Access Compliance Report

Public Rights-of-Way (Curb Ramps)

Intersection ID: 52931	Main Street: WALTHAM_LN	Cross Street: GRAY_OAK_LN	Location: S
ADA ID: 04D58CC18650	Ramp Type: Perp	Initial Pass/Fail: Fail	Overall Compliance: No
Severity Score: 21.25			
Codes/Mitigation Info/Possible Solution		Field Measurements/Component Compliance

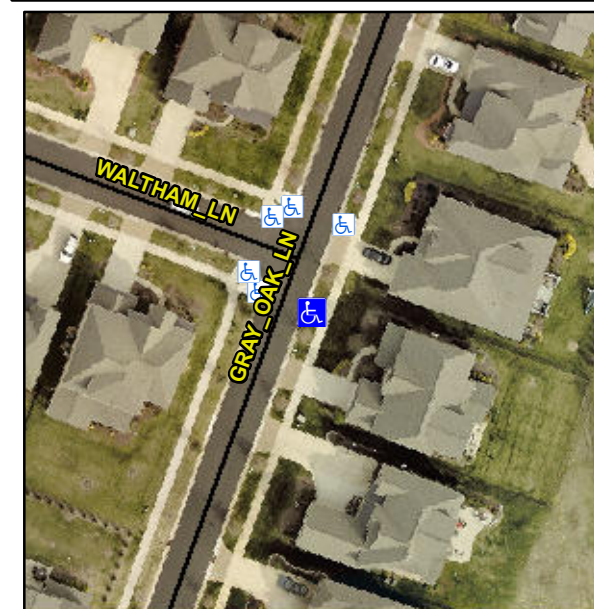
R304.5.1, R304.2.2

Compliance	Description	Data	Compliance	Description	Data
N/A	Ramp Length (in)	95.0	No	Ramp Slope (%)	8.8
No	Ramp Width (in)	47.5	Yes	Ramp XSlope (%)	1.3
N/A	Flare Type LT	N/A	N/A	Flare Type RT	N/A
N/A	Flare Slope LT (%)	N/A	N/A	Flare Slope RT (%)	N/A
N/A	Flare Traversable LT?	N/A	N/A	Flare Traversable RT?	N/A
N/A	Landing Length (in)	N/A	N/A	DWS Provided?	N/A
N/A	Landing Width (in)	N/A	N/A	DWS Contrast?	N/A
N/A	Landing Slope (%)	N/A	N/A	DWS Length (in)	N/A
N/A	Landing X Slope (%)	N/A	N/A	DWS Full Width?	N/A
N/A	Landing Curb? (Y/N)	N/A	N/A	DWS Offset (in)	N/A
N/A	Shared Landing?	N/A			
N/A	Gutter Ponding?	N/A	N/A	Gutter Slope (%)	N/A
N/A	Gutter Lip Ht (in)	N/A	N/A	Gutter X Slope (%)	N/A
N/A	Painted X Walk1?	No	N/A	Painted X Walk2?	N/A
	X Walk 1 Direction	To NW		X Walk 2 Direction	N/A
N/A	X Walk 1 Width (in)	N/A	N/A	X Walk 2 Width (in)	N/A
	X Walk 1 Slope (%)	3.6		X Walk 2 Slope (%)	N/A
	X Walk 1 X Slope (%)	1.9		X Walk 2 X Slope (%)	N/A

Remove & Replace Entire Ramp.
